**STATE OF CALIFORNIA
REGIONAL WATER QUALITY CONTROL BOARD
CENTRAL COAST REGION**

STAFF REPORT FOR REGULAR MEETING OF DECEMBER 7-8, 2017
Prepared on November 1, 2017

SUBJECT: Approval of Cambria Community Services District's Blending of Surface Impoundment Wastewater with Treated Municipal Effluent per Resolution No. R3-2014-0041, General Waiver for Specific Types of Discharges

Figure 1 – Process Flow Diagram

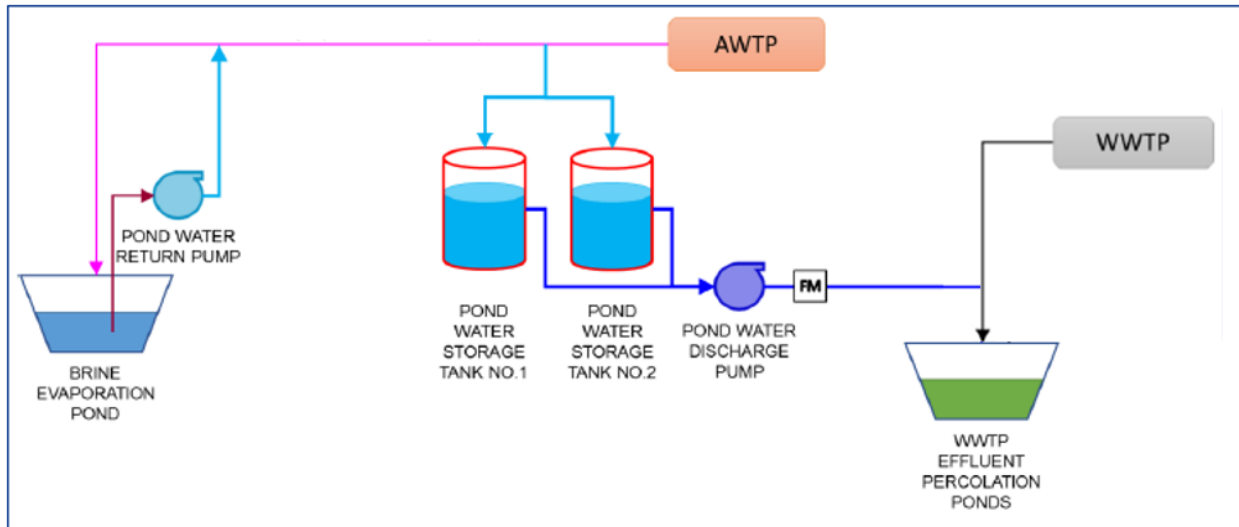
CCSD will blend surface impoundment liquid with wastewater treatment plant effluent before discharging the blend into the percolation ponds. (see Figure 1) .

Figure 3 – Surface Impoundment Area

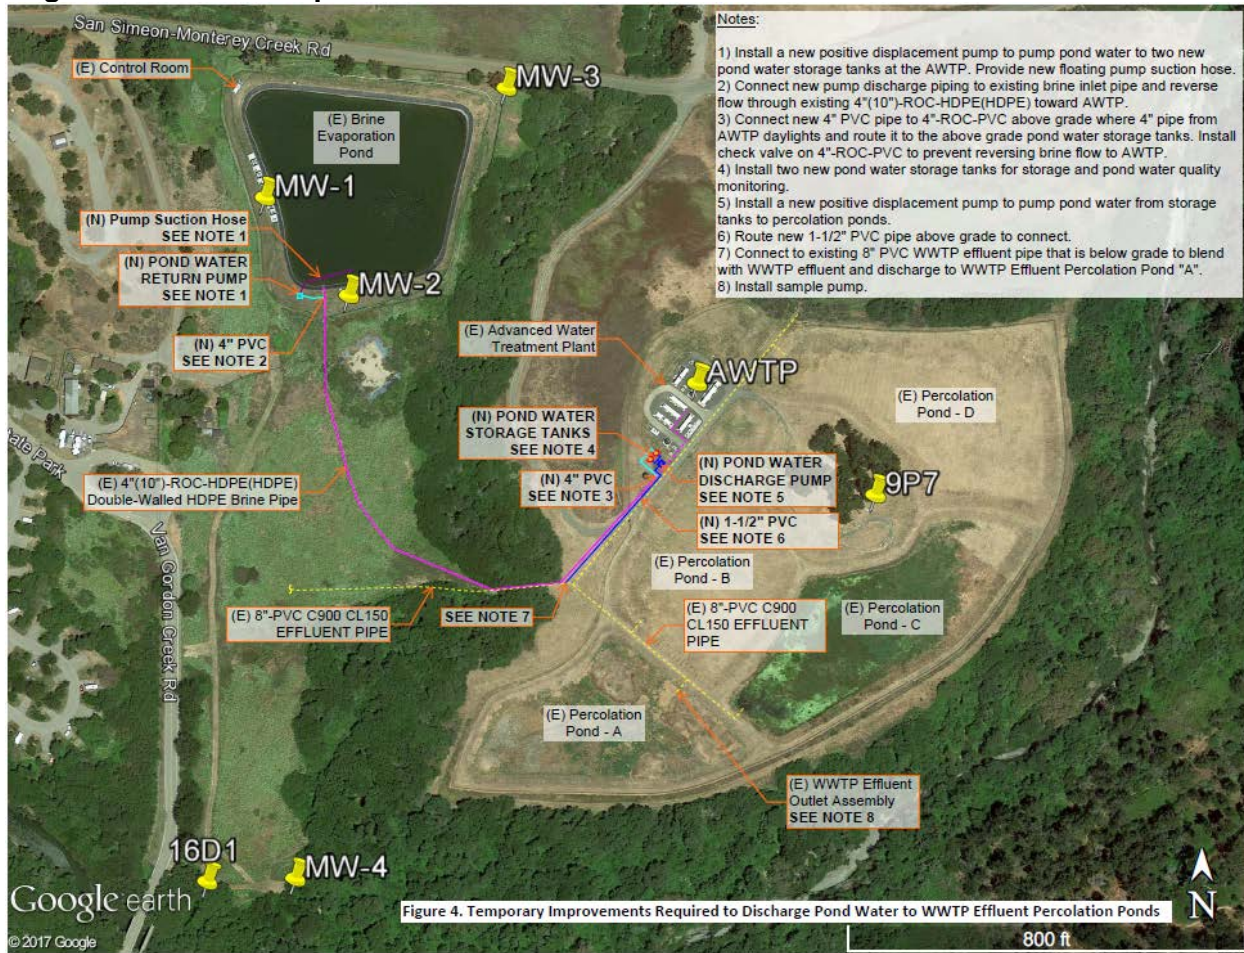
Figure 3 show where impoundment liquid will be injected into the wastewater treatment plant effluent line, prior to discharge into the percolation pond (see note 7 in Figure 3).
